Final Product/Process Change Notification

Document #:FPCN22897X

Title of Change:	Conversion from existing PQFN8x8 Sawn-type package to PQFN8x8 Punch-type package (w/ 2mils Bare Cu wire, Large DC clip and wettable flank feature)	
Proposed First Ship date:	28 Jul 2021 or earlier if approved by customer	
Contact Information:	Contact your local ON Semiconductor Sales Office or RamilAngelo.Nonato@onsemi.com	
PCN Samples Contact:	Contact your local ON Semiconductor Sales Office or < PCN.samples@onsemi.com >. Sample requests are to be submitted no later than 30 days from the date of first notification, Initial PCN or Final PCN, for this change. Samples delivery timing will be subject to request date, sample quantity and special customer packing/label requirements.	
Additional Reliability Data:	Contact your local ON Semiconductor Sales Office or Aileen.Allado@onsemi.com	
Type of Notification:	This is a Final Product/Process Change Notification (FPCN) sent to customers. FPCNs are issued 90 days prior to implementation of the change. ON Semiconductor will consider this change accepted, unless an inquiry is made in writing within 30 days of delivery of this notice. To do so, contact PCN.Sup

3D Model Comparison

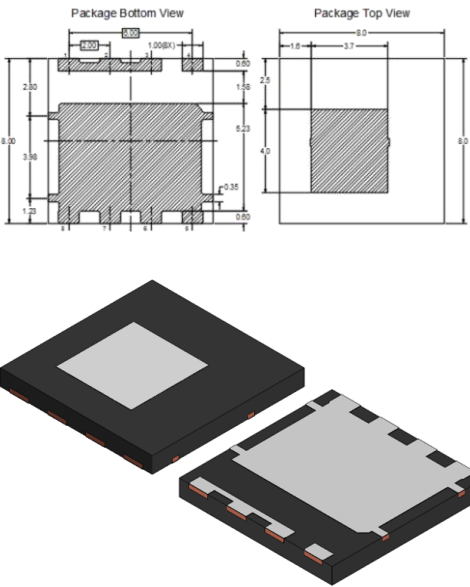
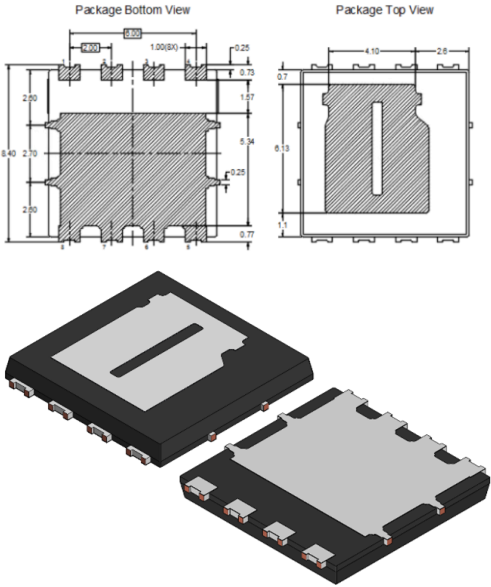
Before Change Description	After Change Description
LeadFrame	Etched Type	Stamped Clip
Bond Wire	1.0mils PCC/ Cu Clip 10mils with Cu Heatslug 10mils	2mils Cu wire/ 1pc Cu Clip 20mils
Mold Compound	Hitachi CEL9240HF10LS	Sumitomo G700LTD SF
Package Type	Sawn	Punch

Before Change Description	After Change Description
<p>Package Appearance</p>	 <p>Package thickness : 0.85mm nominal</p>	 <p>Package thickness : 0.92mm nominal</p>
